Re: Permit No. M-1980-244; Cripple Creek & Victor Gold Mining Company; Cresson Project; Adequacy Review Response to Technical Revision 128 – Ironclad Facilities Access Road Re-Alignment

**ATTACHMENT 1:
PROPOSED ACCESS ROAD & NON-
JURISDICTIONAL WETLANDS MAP**

Proposed Access Road & Non-Jurisdictional
Wetlands Map

Appendix 6: Section 2 Auto-Refine Slope Analysis Results, Global Minimum FoS of 1.628. All surfaces below FoS of 2.0 are shown. Location of County Road 82 shown with the lateral distance from CR82 to the proposed access road annotated for reference (100.4 ft for Section 2).

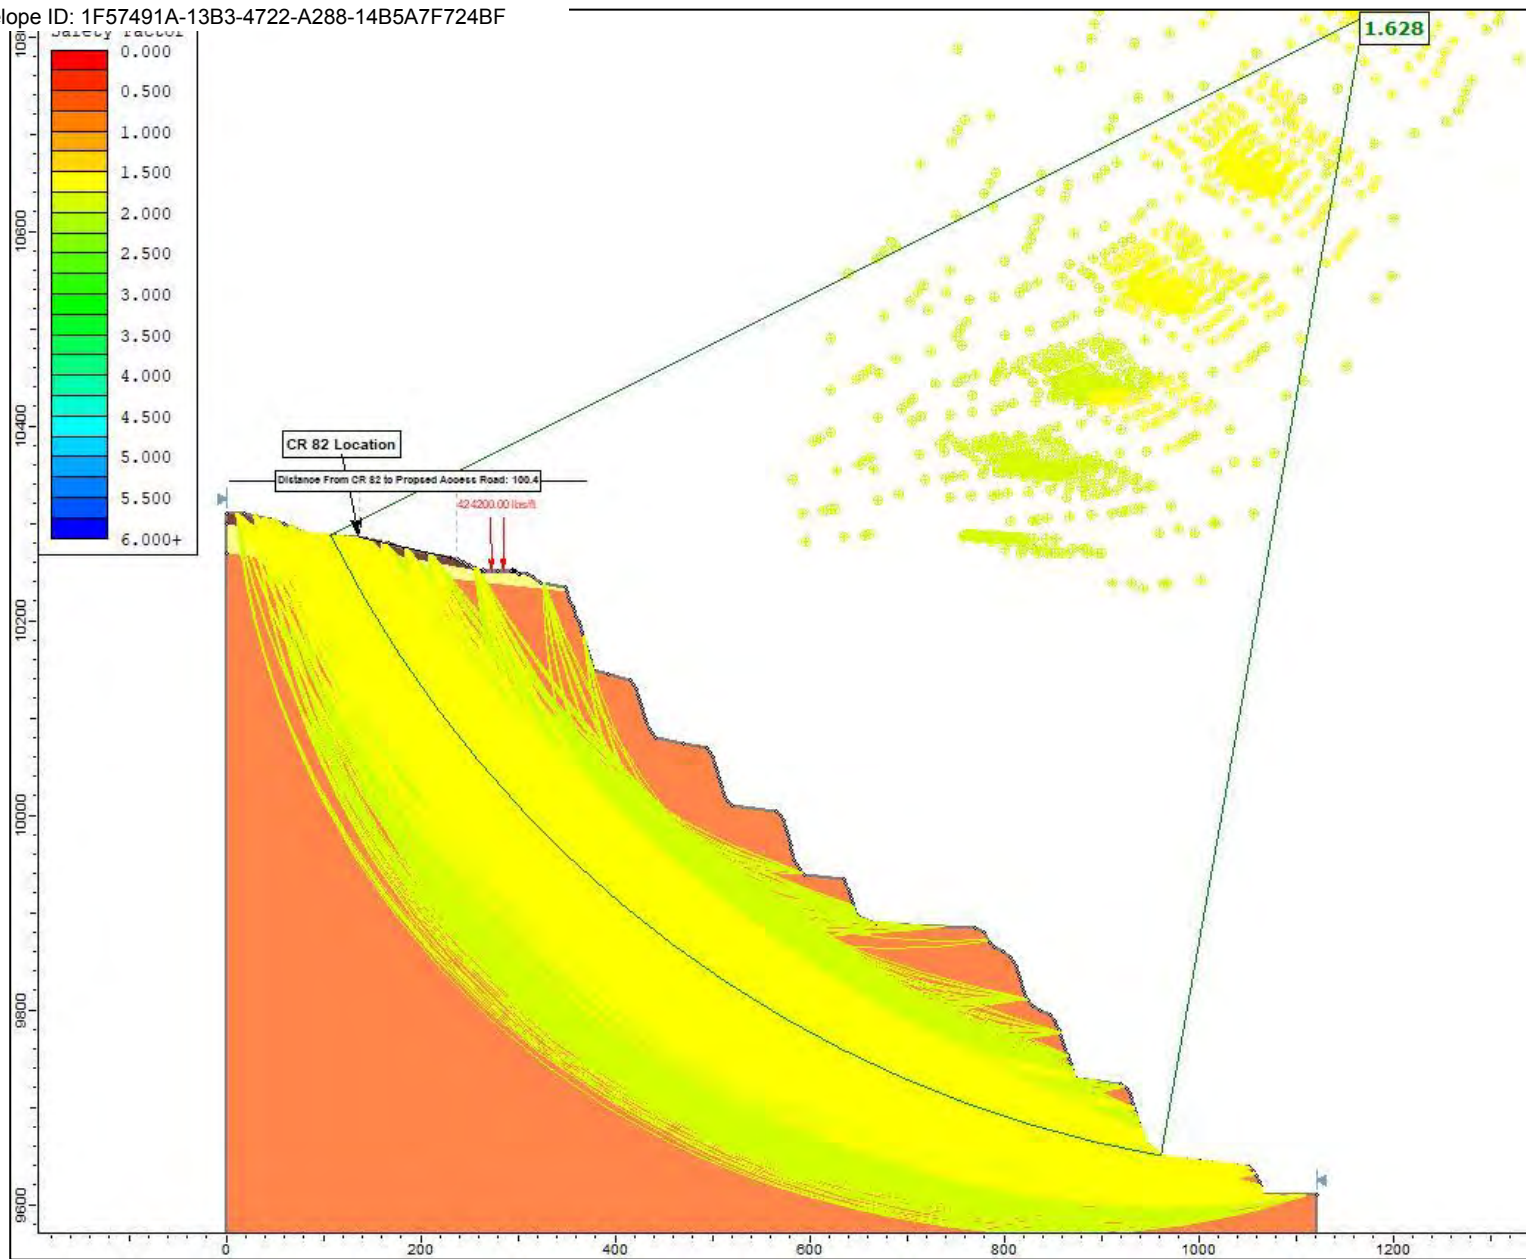
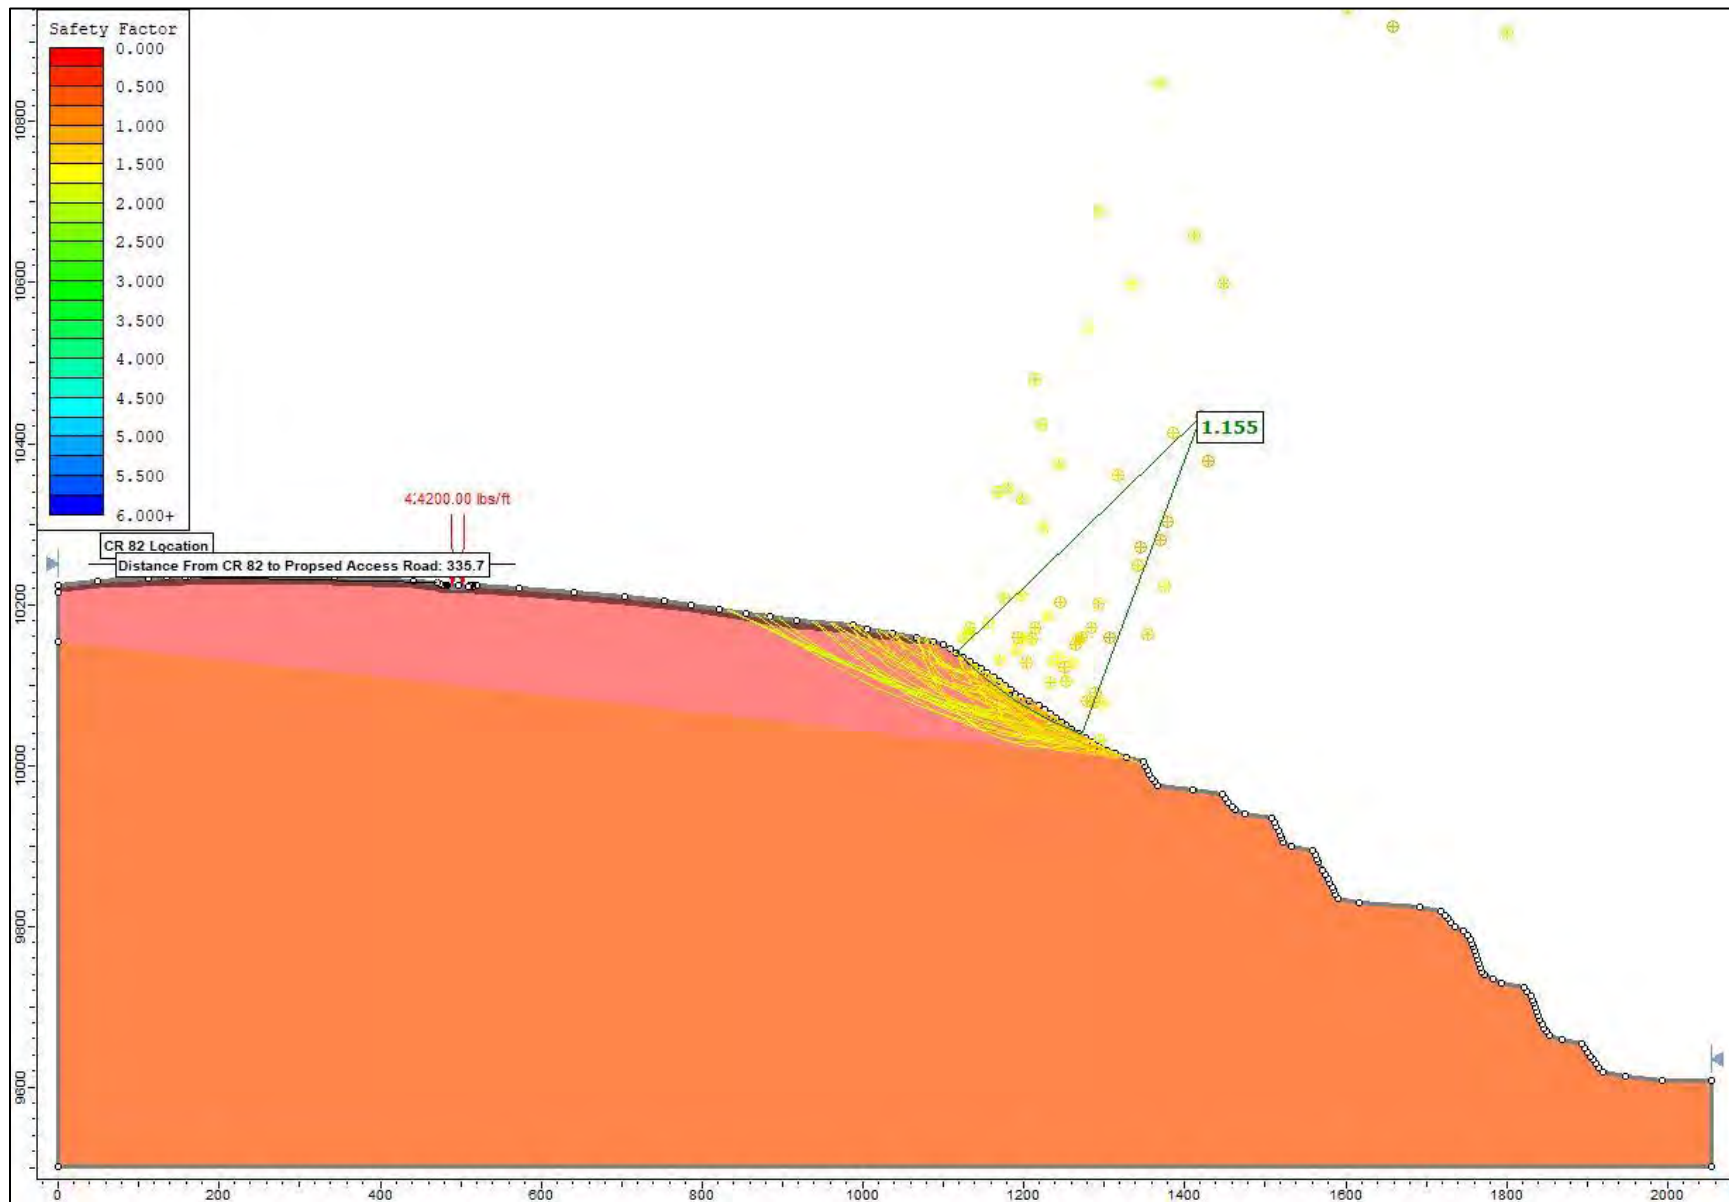
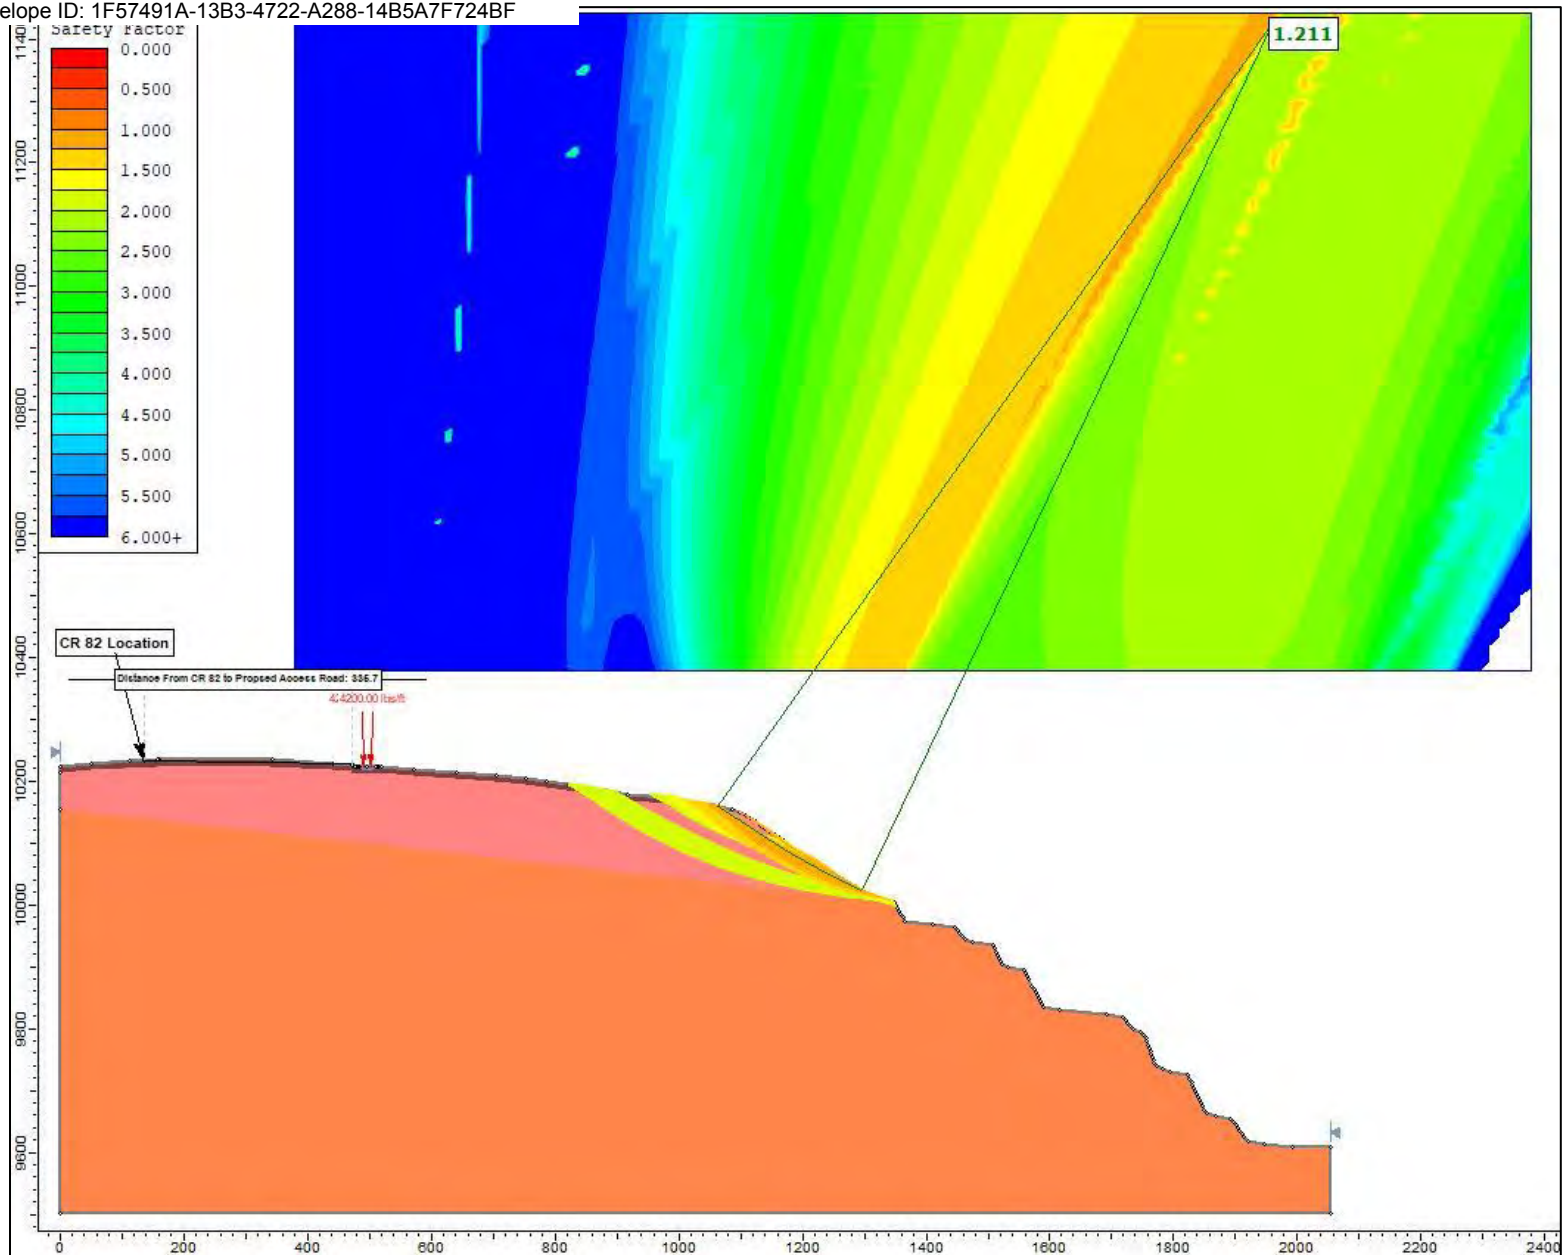
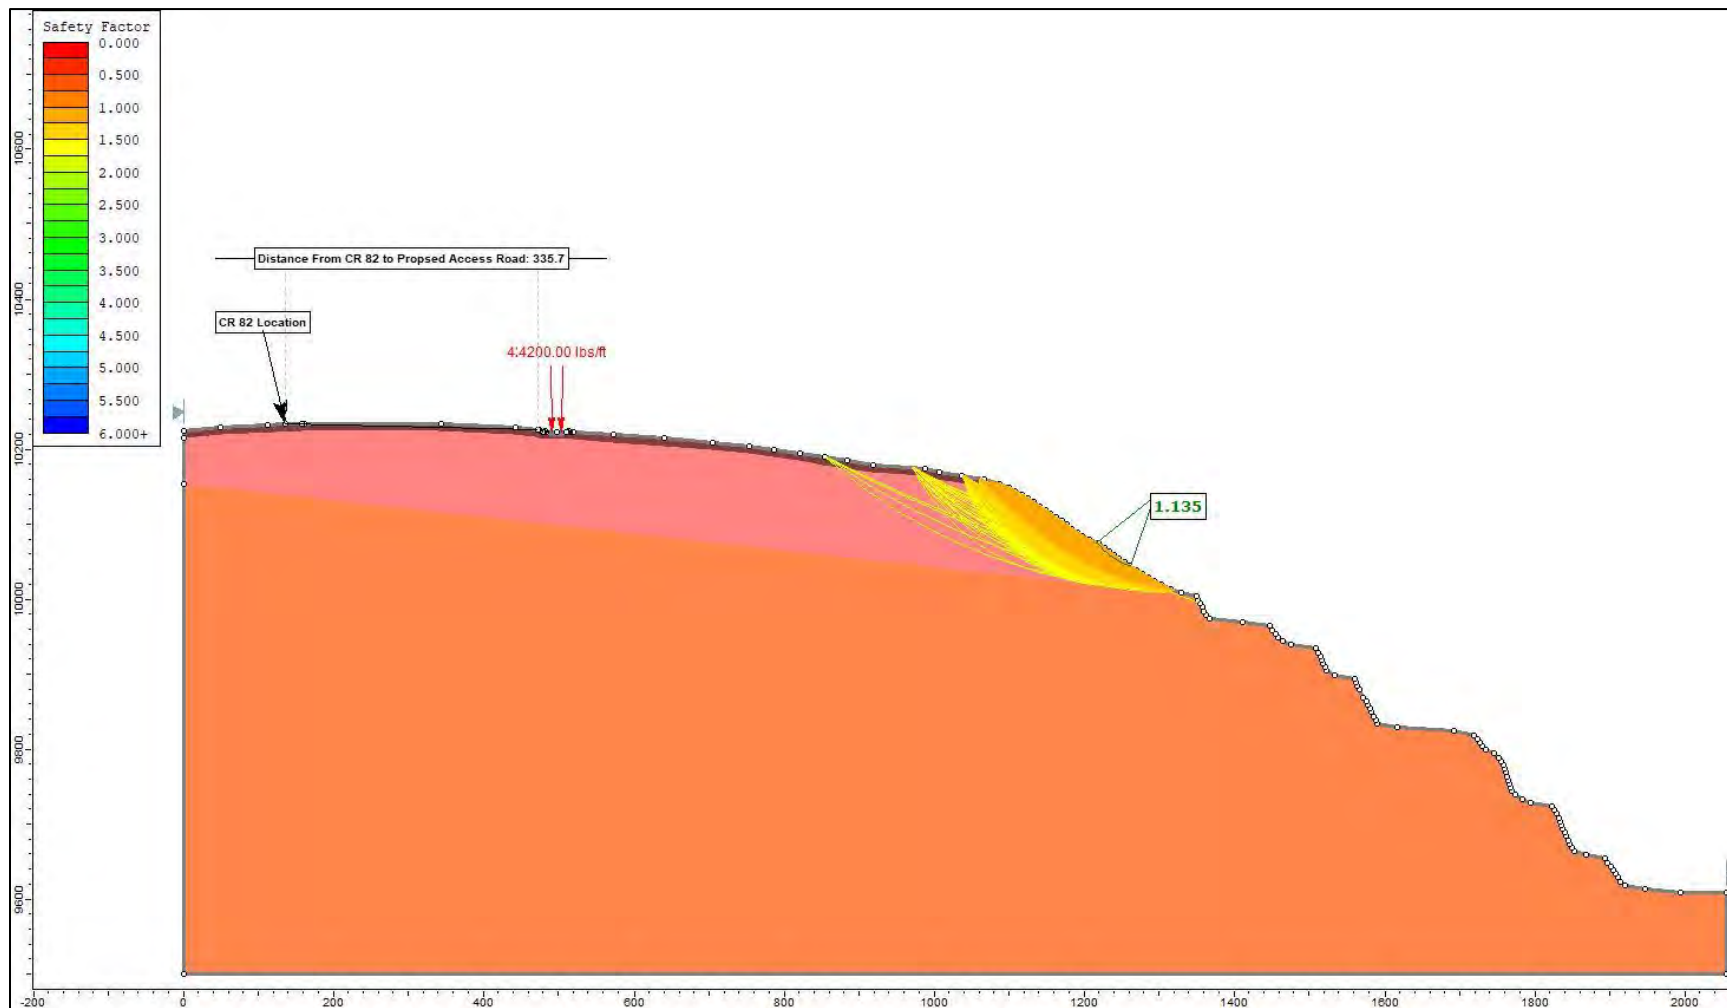
- 9. Please submit a geotechnical stability analysis showing the addition of the road along the crest of the WHEX Pit highwalls does not affect the stability of the highwalls. The analysis will need to specifically cover the portions of the road from Station 2+00 to 10+00 and 32+00 to 42+00. The analyses should account for two simultaneously passing semi-trucks (H-20 loading) within these designated sections of the proposed road.**

Cross Section #	Analysis Method	FoS	
Section 1	Grid Analysis	1.305	Average
	Slope Search	1.228	1.286
	Auto-refine Search	1.325	
Section 2	Grid Analysis	1.633	Average
	Slope Search	1.642	1.634
	Auto-refine Search	1.628	
Section 3	Grid Analysis	1.211	Average
	Slope Search	1.155	1.167
	Auto-refine Search	1.135

The analysis showed that the location of the proposed haul road, as well as the loading from delivery trucks, does not affect the stability of the highwalls. The standard for the minimal FoS for this analysis is defined in the revised policies Mined Land Reclamation Board (MLRB). Section 30.3 and 30.4 of the MLRB revised policies outlines the guidance for minimum FoS standard of 1.3 for construction slopes near roadways and utilities. Cross Section 2, average FoS of 1.634 is higher than the minimum allowable FoS of 1.3 (see Appendices 4-6) Cross sections 1 and 3 show an average FoS of 1.286 and 1.167 respectively (See Appendices 1-3 and 7-9). These FoS are below the minimum of 1.3, however the surfaces that display these minimums represent smaller, superficial instability rather than global slope instability. For both Cross Sections 1 and 3, the minimum FoS values can be attributed to the weaker material properties assigned to the Valley Fill and Weathered Breccia materials. This failure type is consistent with current field conditions and is being managed and monitored by the CC&V Geotechnical group. Monitoring of the ground conditions during the construction of the proposed access road will be undertaken by CC&V Mine Operations and Mine Technical Services. Additional geotechnical monitoring will be installed to ensure the long-term stability of the proposed access road re-alignment.
